Crystal River Nuclear Plant
Docket No. 50-302
Operating License No. DPR-72

Subject: Crystal River Unit 3 – Relief Request #07-003-RR, Revision 1, and Response to Request for Additional Information

RELIEF REQUEST #07-003-RR, REVISION 1

RESPONSE TO REQUEST FOR ADDITIONAL INFORMATION

Fig. 2 Preservice and Inservice Examination Volume

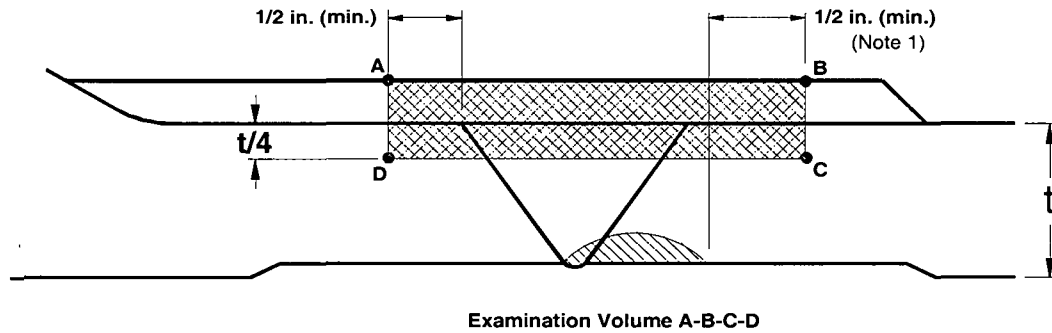
- c) Code Case N-740-1, Draft February 2007 is not explicit on examination requirements associated with an Alloy 600 safe end SWOL. The figures generally depict examination volumes associated with the weld. What acceptance examinations, preservice examinations, and inservice examinations are planned for the SWOL of the Alloy 600 safe end and what are the volumes to be examined?**
